Well Name: LOST TANK 30-19 FEDERAL COM	Well Location: T22S / R32E / SEC 19 / NENW / 32.3831909 / -103.7175353	County or Parish/State: LEA / NM
Well Number: 21H	Type of Well: OIL WELL	Allottee or Tribe Name:
Lease Number: NMNM090587, NMNM90587	Unit or CA Name:	Unit or CA Number:
US Well Number: 3002547942	Well Status: Approved Application for Permit to Drill	Operator: OXY USA INCORPORATED

Notice of Intent

Sundry ID: 2758998

Procedure Description: OXY USA INC. Respectfully requests approval to make changes to our approved APD, see the following change requests below: Update Surface Hole: from Sec 19, T22S, R32E, 373' From the North and 1701' From the West, to the new location of Sec 19, T22S, R32E, 353' From the North and 2049' from the West. Update Bottom Hole: from Section 30 T22S, R32E, 20' from the South and 1340' from the West, to the new location of Section 30, T22S, R32E, 20' From the South and 1640' From the West. Changes to our 3 string casing design. Please see the attached updated drill plans, along with specs for the casing strings.

Wellhead diagram during offline cementing operations

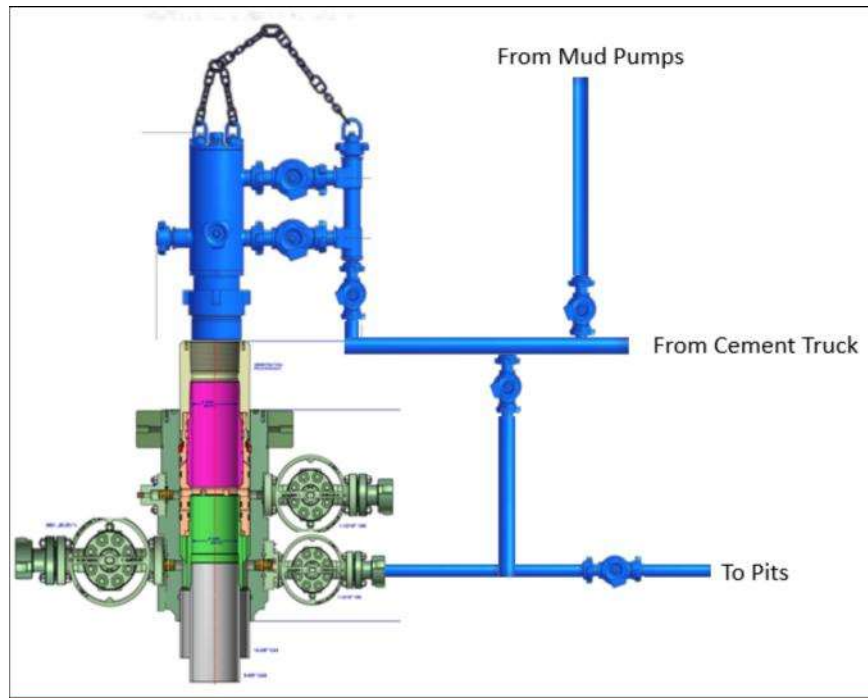
1. Run casing as per normal operations. While running casing, conduct negative pressure test and confirm integrity of the float equipment (float collar and shoe)
2. Land casing with mandrel
3. Fill pipe with kill weight fluid, do not circulate through floats and confirm well is static
4. Set annular packoff shown below and pressure test to confirm integrity of the seal.
Pressure ratings of wellhead components and valves is 5,000 psi

5. After confirmation of both annular barriers and internal barriers, nipple down BOP and install cap flange.
 - a. If any barrier fails to test, the BOP stack will not be nipped down until after the cement job is completed with cement 500ft above the highest formation capable of flow with kill weight mud above or after it has achieved 50 psi compressive strength if cannot be verified.

6. Skid rig to next well on pad.
7. Confirm well is static before removing cap flange, flange will not be removed and offline cementing operations will not commence until well is under control. If well is not static, casing outlet valves will provide access to both the casing ID and annulus. Rig or third party pump truck will kill well prior to cementing or nipping up for further remediation.

Break Testing Procedures

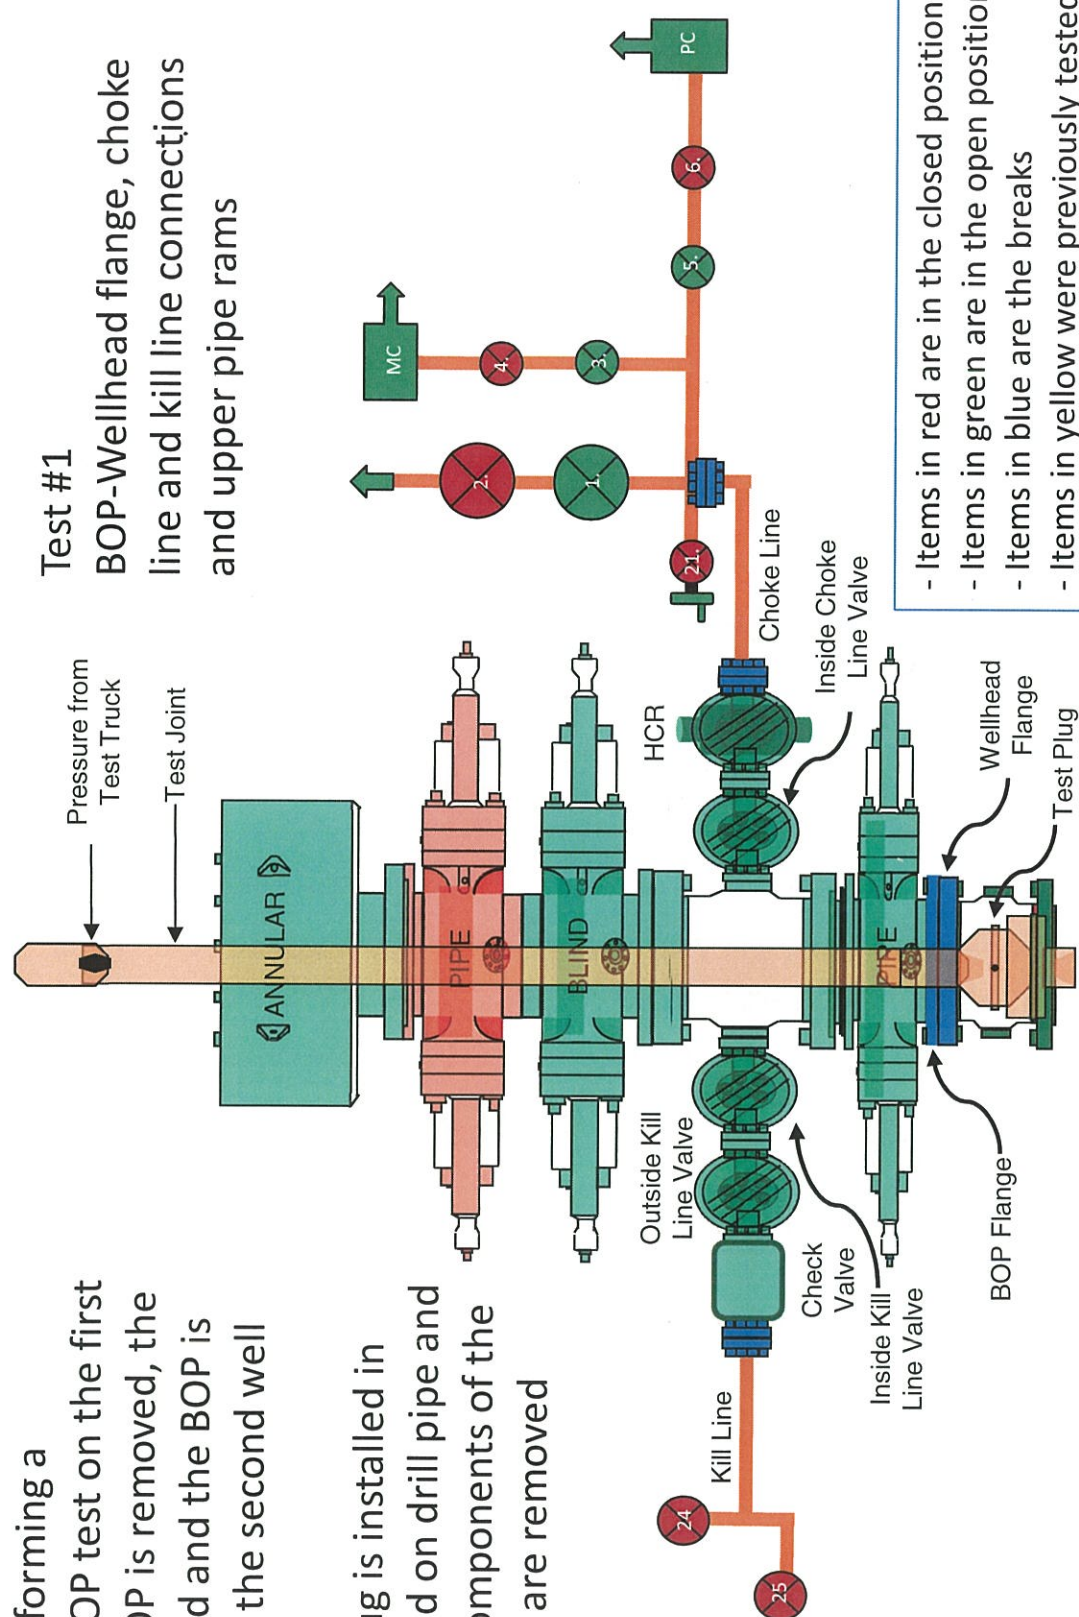
- 8) A shell test is performed against the upper pipe rams testing all three breaks
- 9) The internal parts of the check valve are reinstalled and the HCR valve is closed.
A second test is performed on them
- 10) These tests consist of a 250 psi low test and a high test to the value submitted in the APD or SN (e.g., 5000 psi)
- 11) Perform a function test of components not pressure tested to include the lower pipe rams, the blind rams and the annular
- 12) If this were a three well pad, the same three breaks on the BOP would be made and steps 4 through 11 would be repeated
- 13) A second break test would only be done if the third hole section could be completed within the 30-day BOP test window
- 14) If a second break test is performed, additional components that were not tested on the first break test will be tested

Break Testing Procedures and Tests

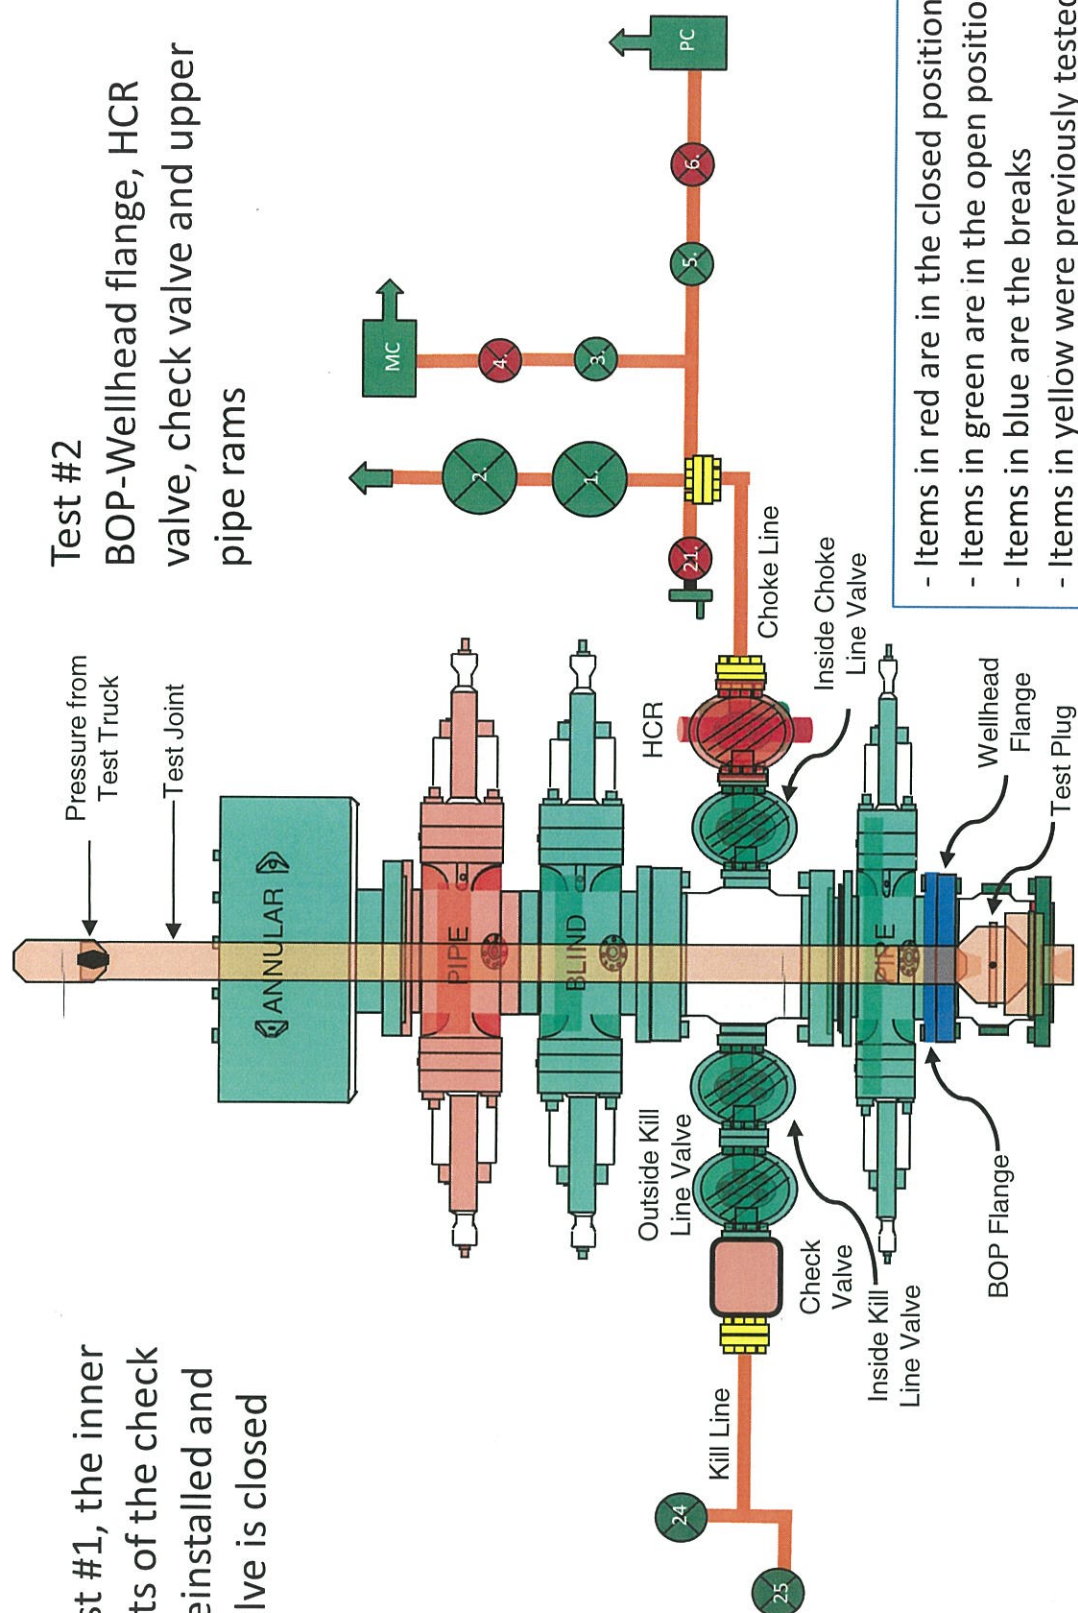
3. After Test #1, the inner components of the check valve are reinstalled and the HCR valve is closed
